CITY OF SAMMAMISH EBRIGHT CREEK FISH PASSAGE

30% SUBMITTAL

VICINITY MAP
N.T.S.

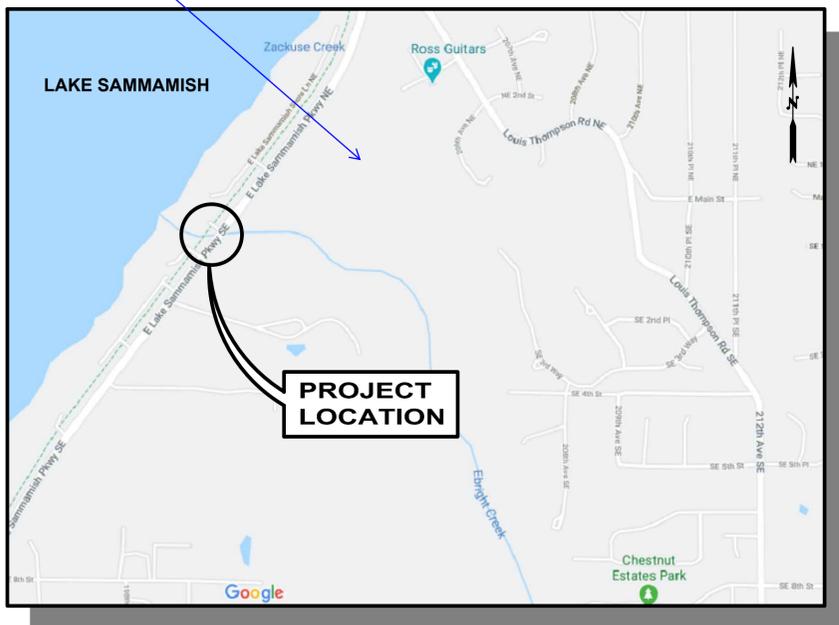
Add project vicinity in the region. Improve legibility of road names.

May need to include Zayo and Verizon (Fiber backbones)

EBRIGHT CREEK FISH PASSAGE
 CITY OF SAMMAMISH
 TESC AND DEMO PLAN

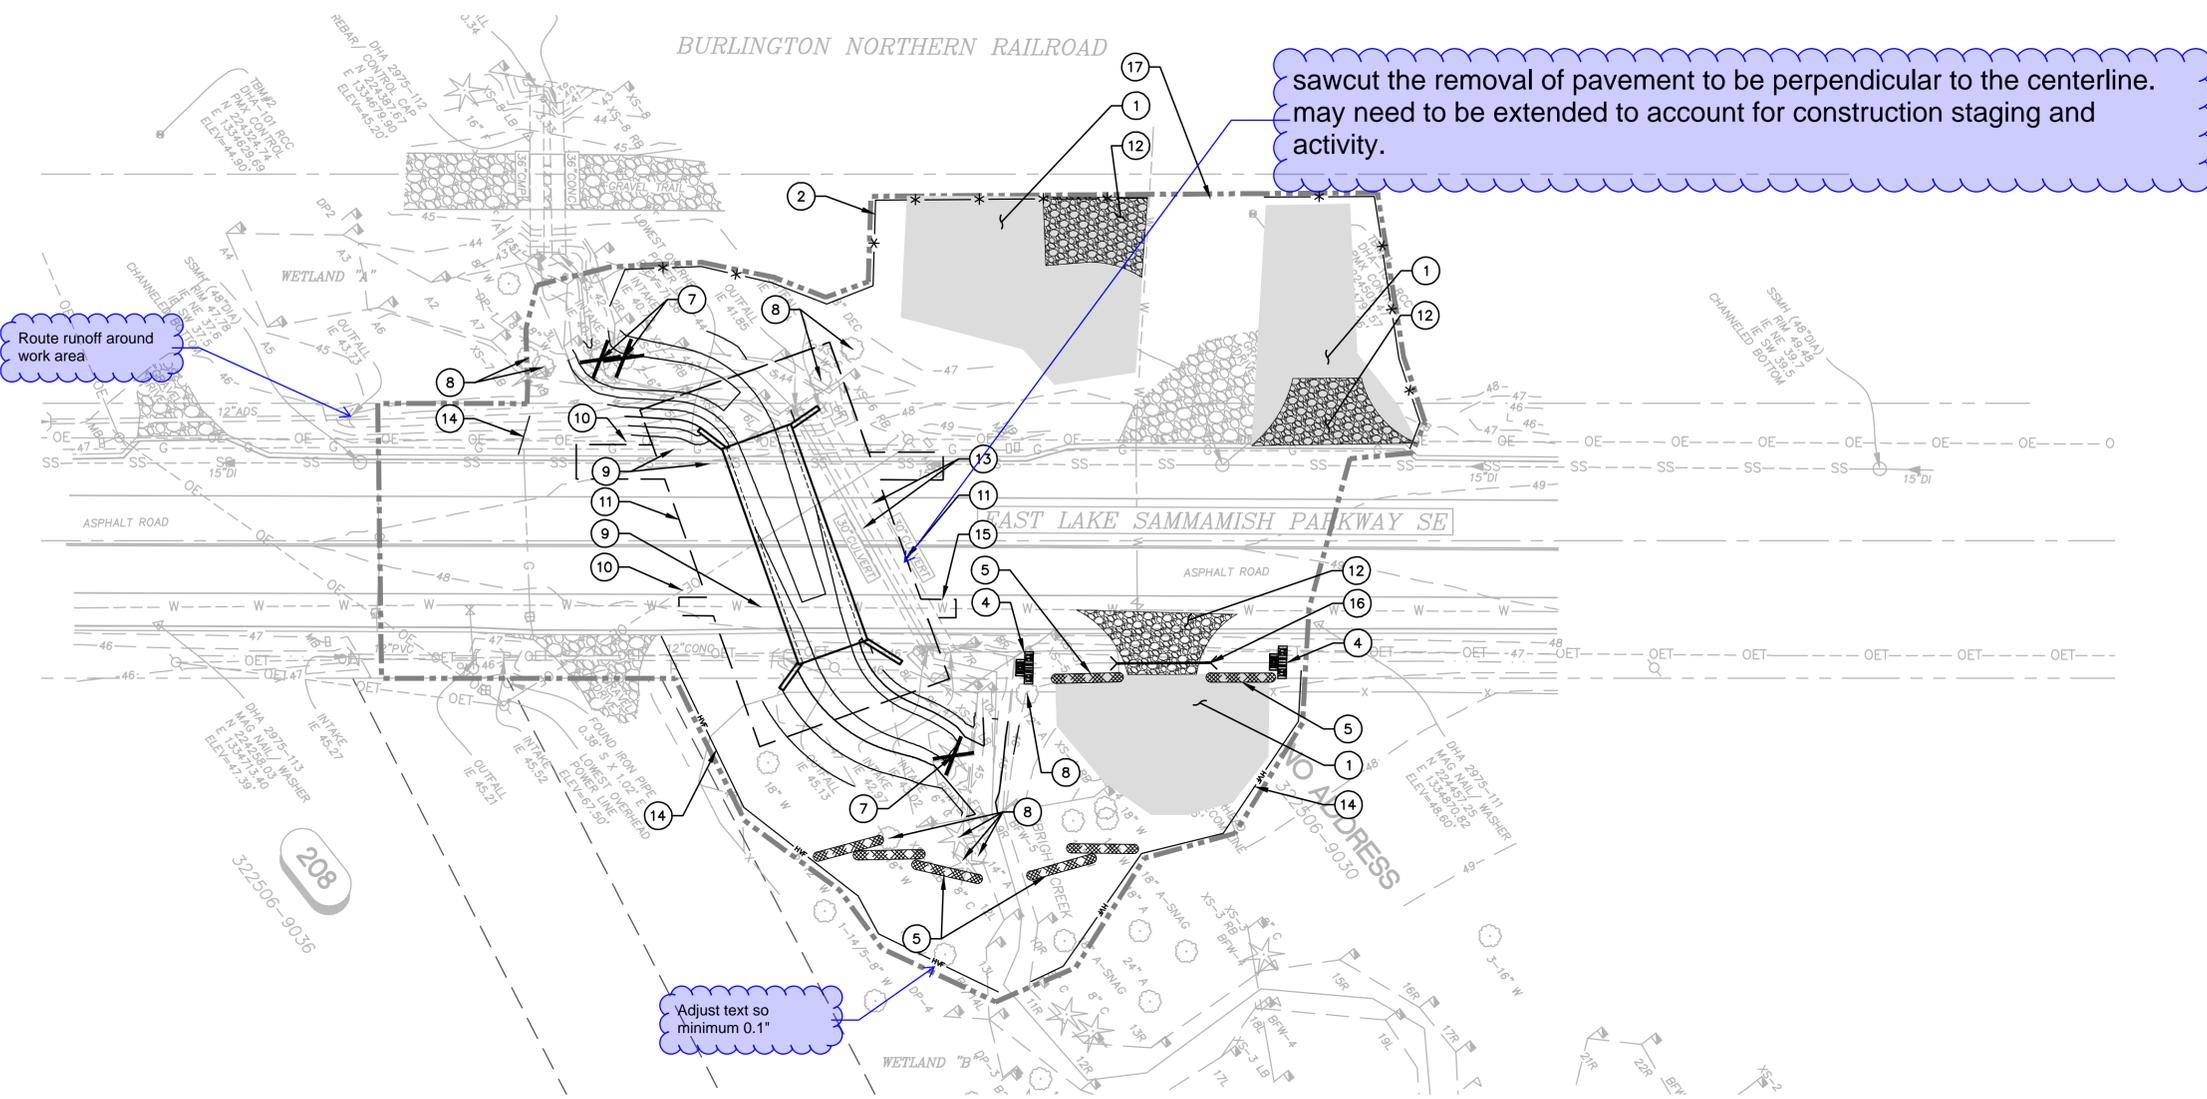
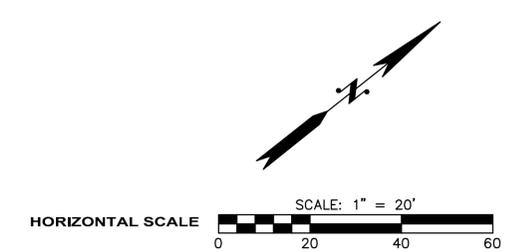
sawcut the removal of pavement to be perpendicular to the centerline. may need to be extended to account for construction staging and activity.

Route runoff around work area

Adjust text so minimum 0.1"

Add note regarding easements required.

Is this item represented in the figure above?

Note: Tree protection required if tree is within work area and replanting needed for trees removed. Follow Sammamish tree protection code SMC 21A.37.

EBRIGHT CREEK FISH PASSAGE
 CITY OF SAMMAMISH
 STREAM BYPASS PLAN

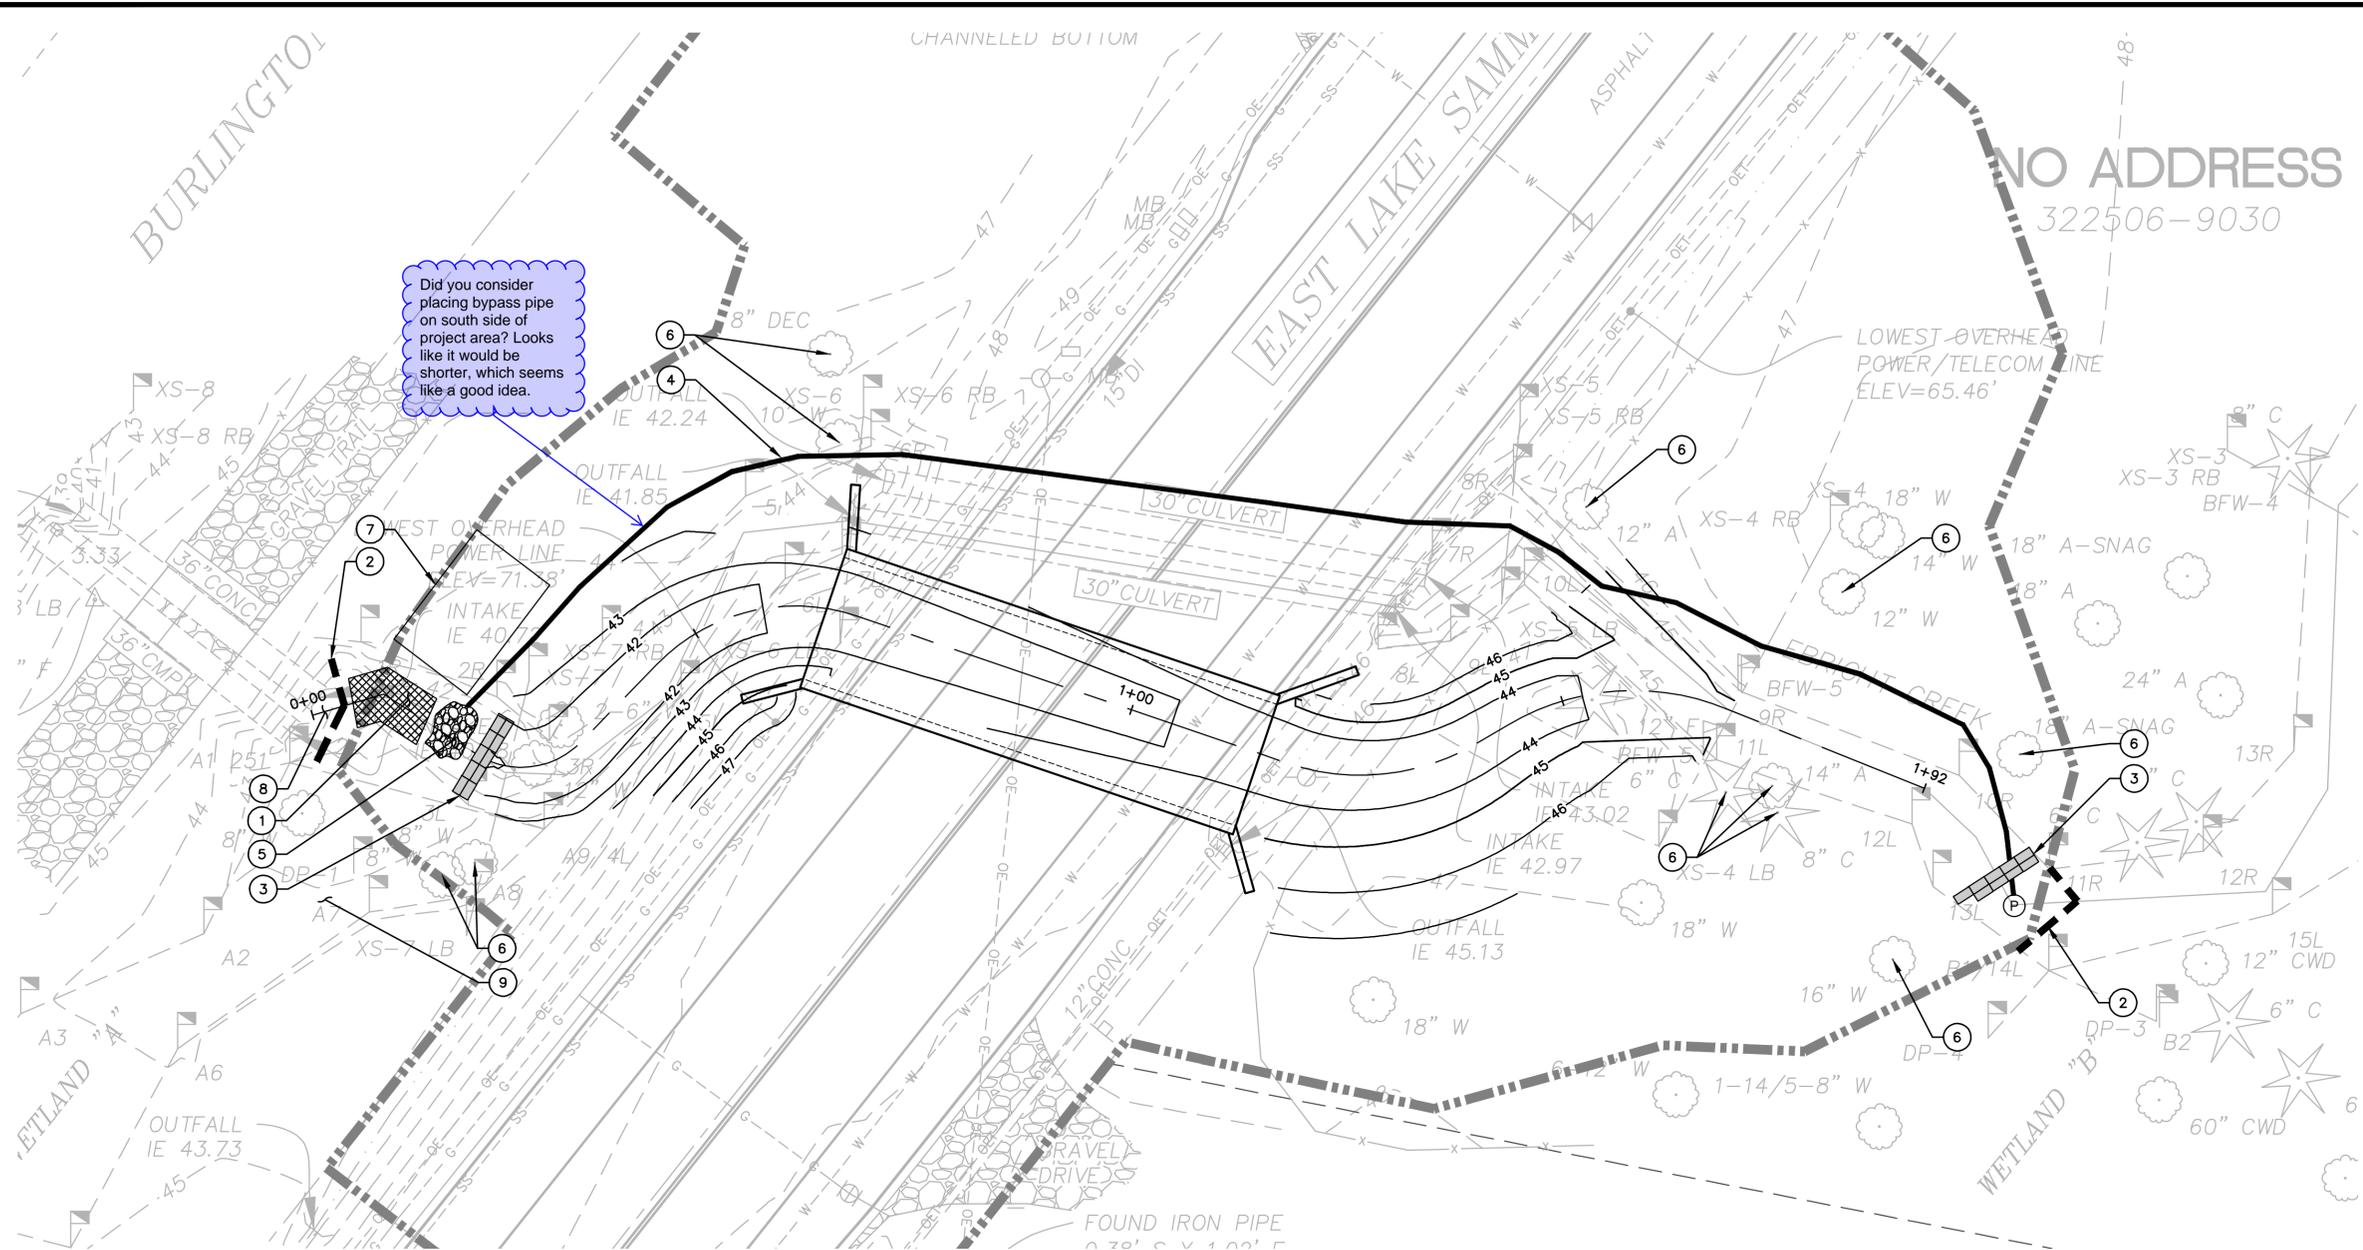
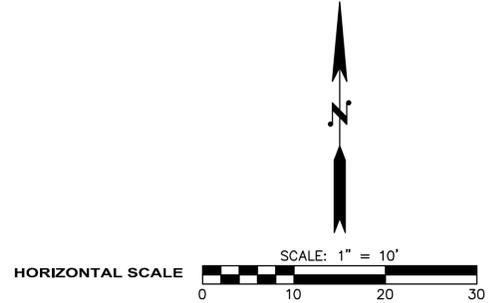
Did you consider placing bypass pipe on south side of project area? Looks like it would be shorter, which seems like a good idea.

Do we need to add profile of the bypass pipe?

Can we utilize the existing culvert as the bypass?

B-B EBRIGHT CREEK CENTERLINE PROFILE
SCALE: 1"=10'

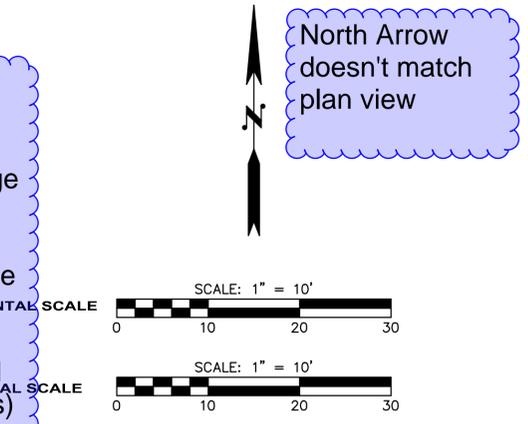
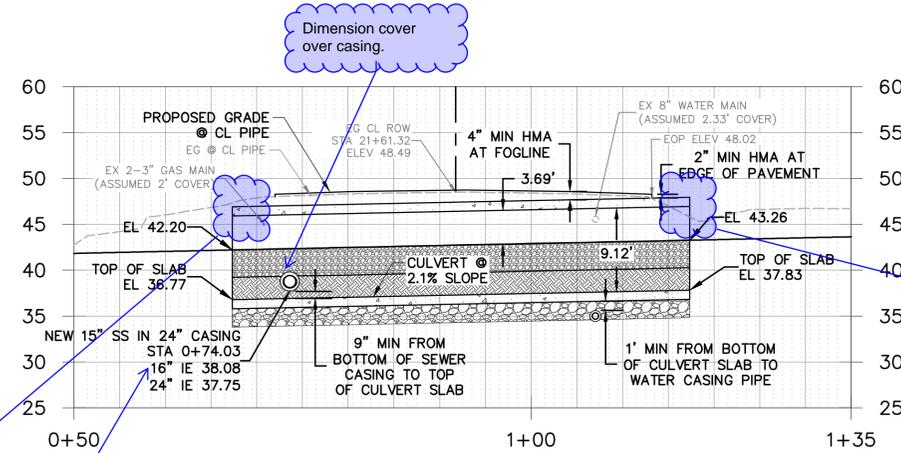
This may need to be thicker based on AASHTO Bridge Design. May need new proposed profile of roadway or riding surface box. (will need approach slabs)

A-A SEWER PROFILE
SCALE: 1"=10'

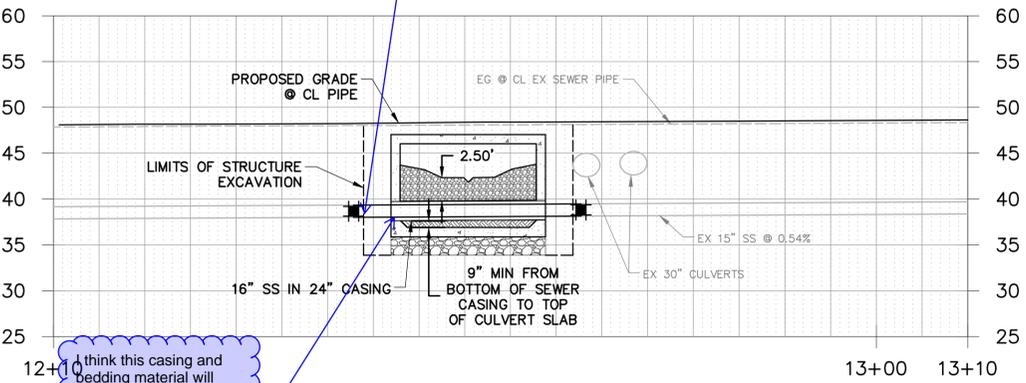
Casing gets extended past the box enough to maintain.

D-D WATER MAIN PROFILE
SCALE: 1"=10'

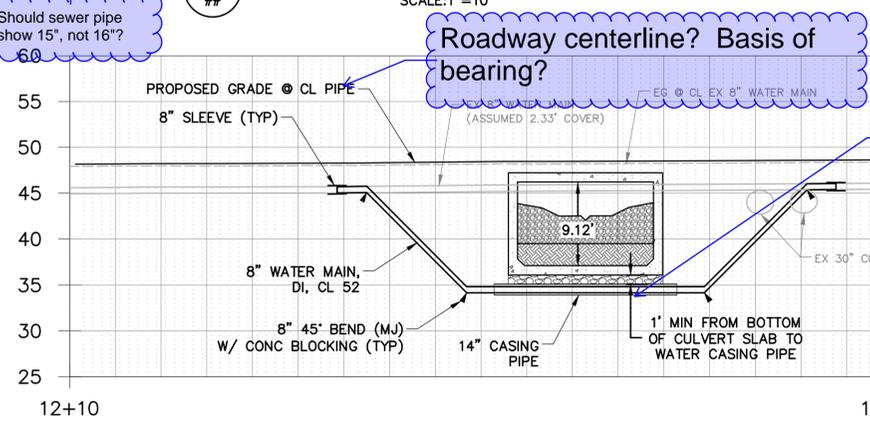
Verify with Sam Plat. may need restrained joints. Show thrust blocks and anchors.
It may be easier to keep existing elevation with casing, if a feasible option.

EBRIGHT CREEK FISH PASSAGE
 CITY OF SAMMAMISH
 STREAM CHANNEL GRADING PLAN AND PROFILE

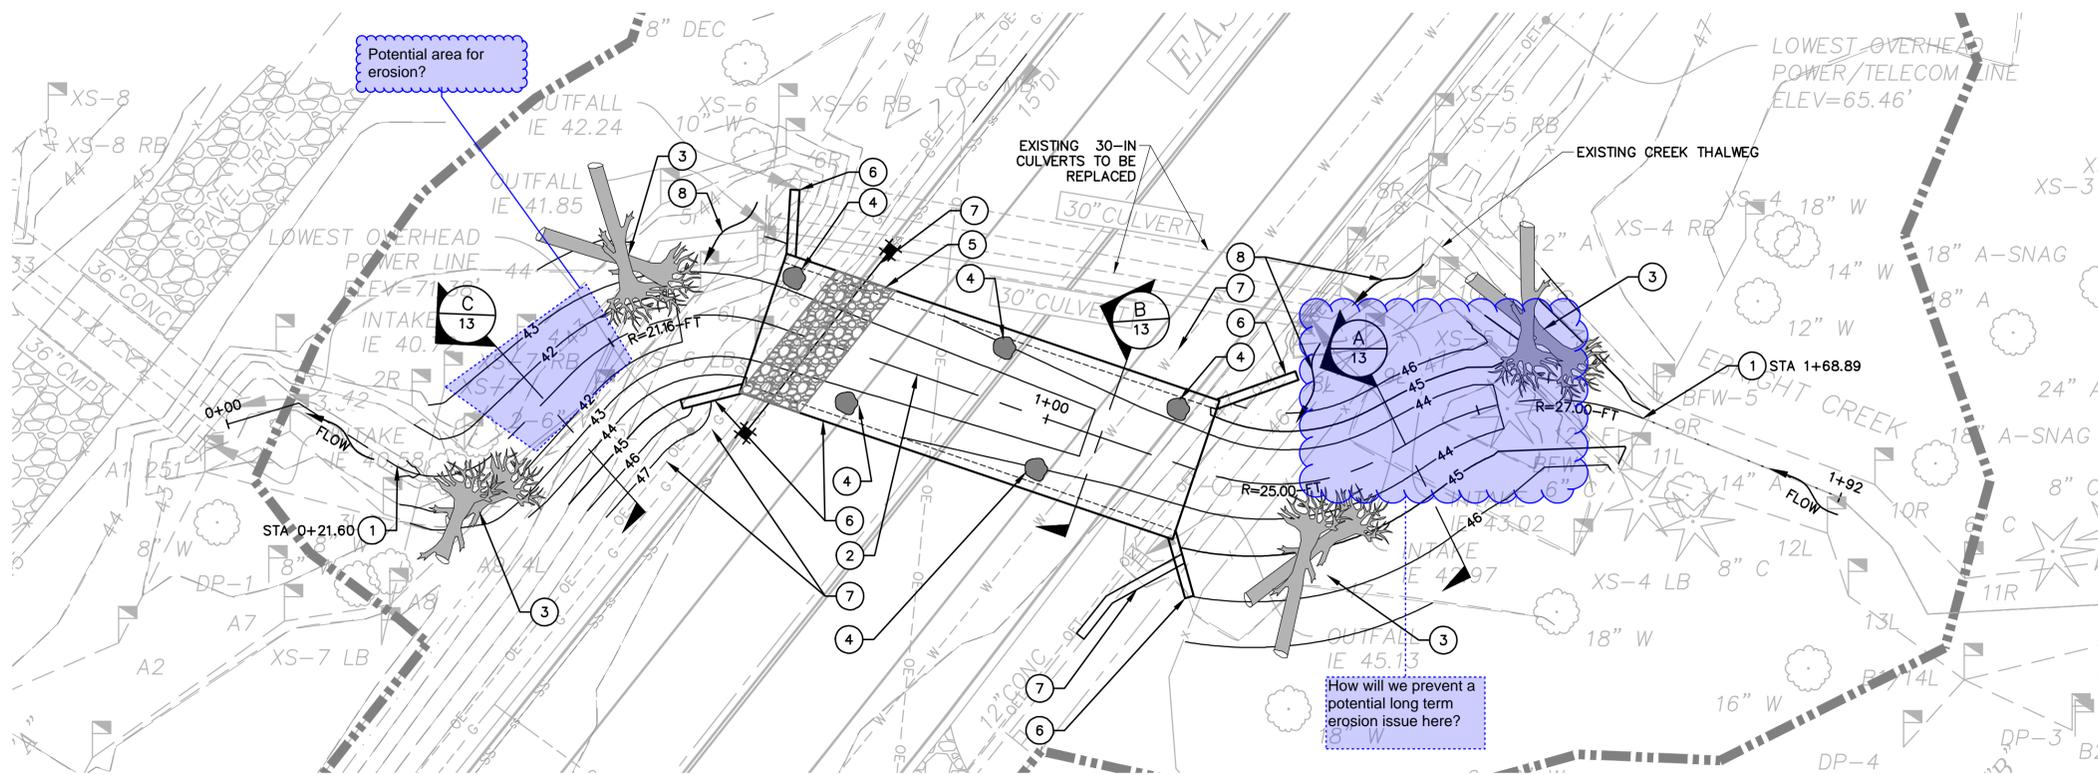
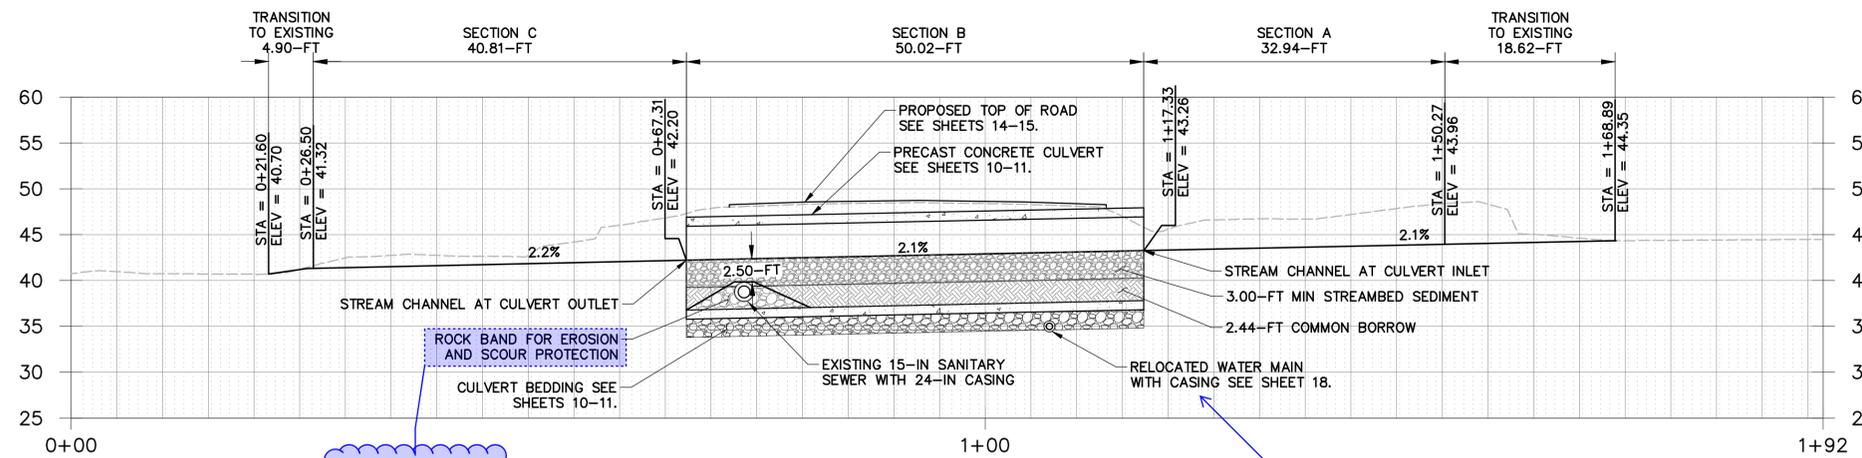
If compacted to density, this seems like a reasonable way to protect the sewer from being exposed. Is there more we could do to prevent that possibility?

Is it possible to relocate and avoid casing the water? Let's discuss risks and costs of this.

A UPSTREAM CHANNEL DETAIL
 12 N.T.S.

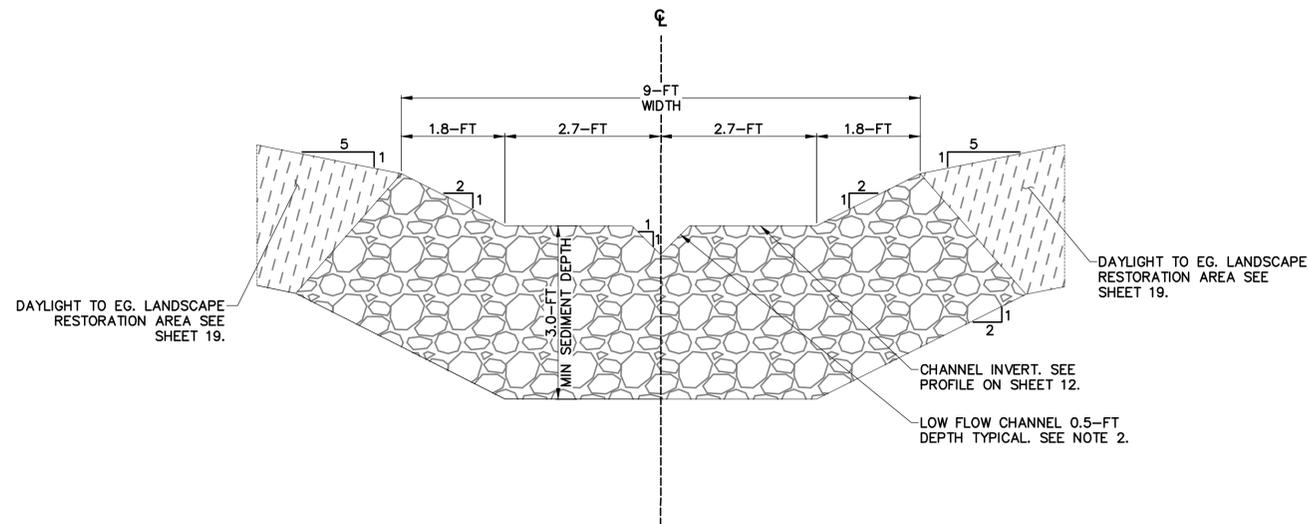
Consider armoring bends at channel inlet and outlet to prevent future erosion?
